Morris Goding
Access Consulting

11-13 Mannix Parade,
Warwick Farm

Access Review – DA 3

11 August 2020

2 Balcony/ Balustrade Section Detail 1:20

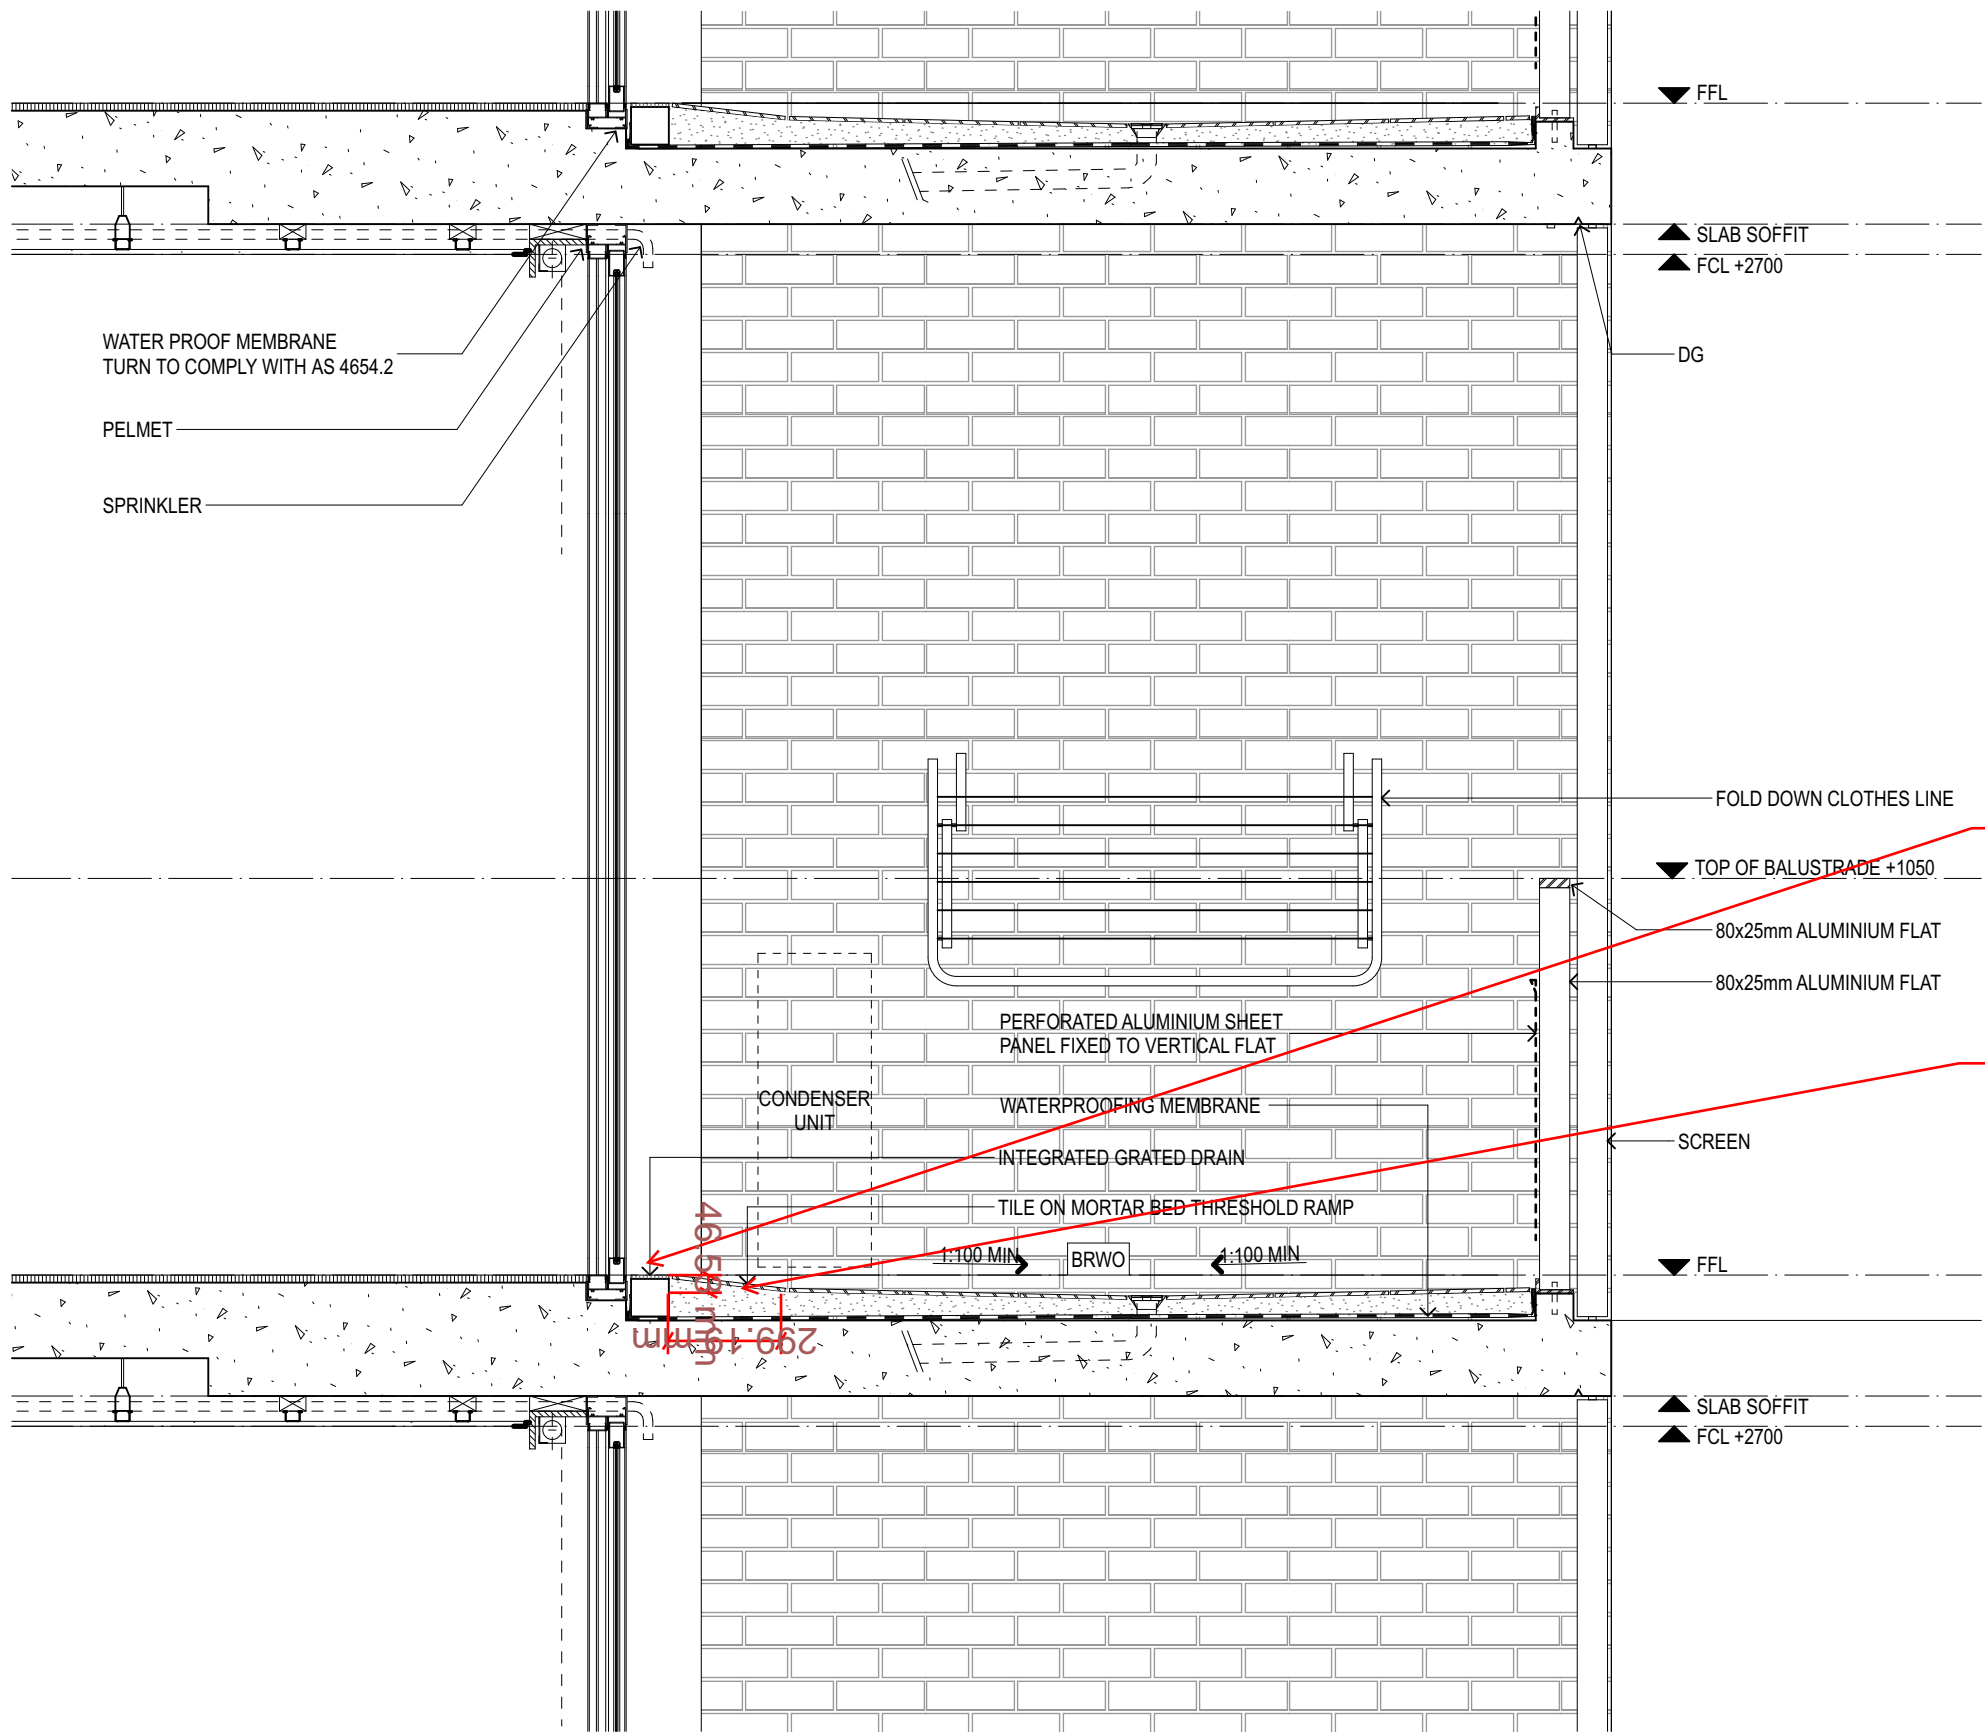
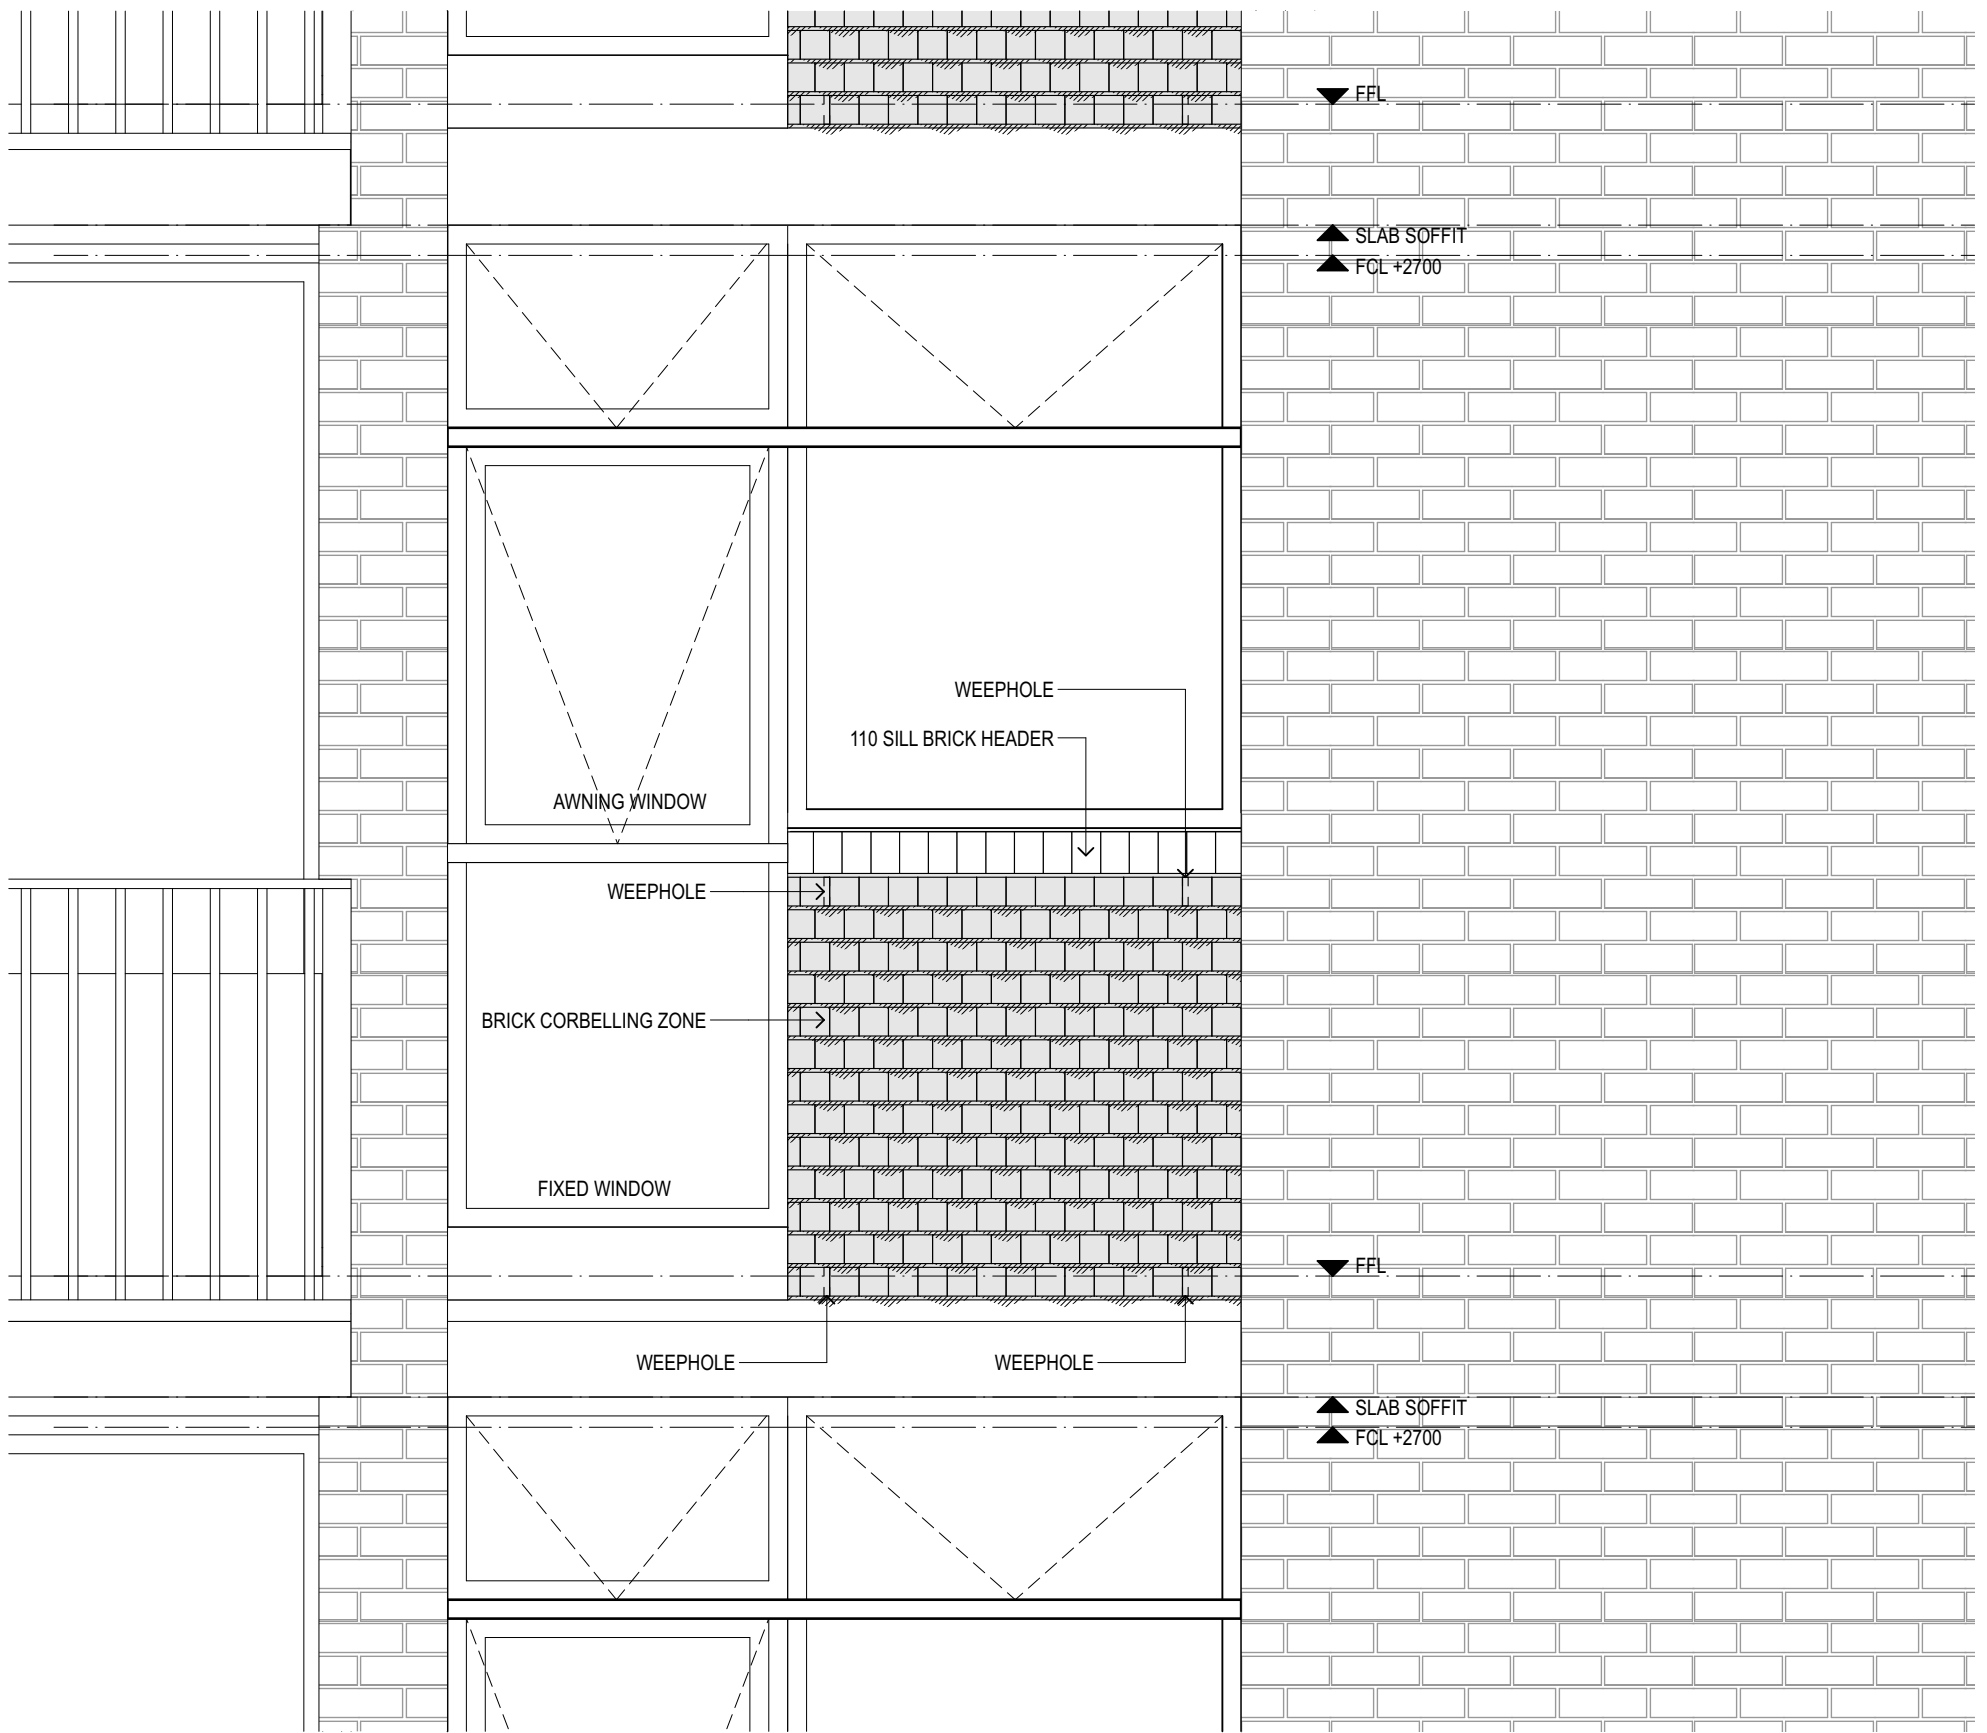
General note:
Grated drain to comply with AS 1428.1 (2009) Clause 7.5.

Threshold ramp to be 1:8 (max rise of 35mm and max length of 280mm) and located within 20mm of the door leaf. Currently not per AS 1428.1 (2009) Clause 10.5.
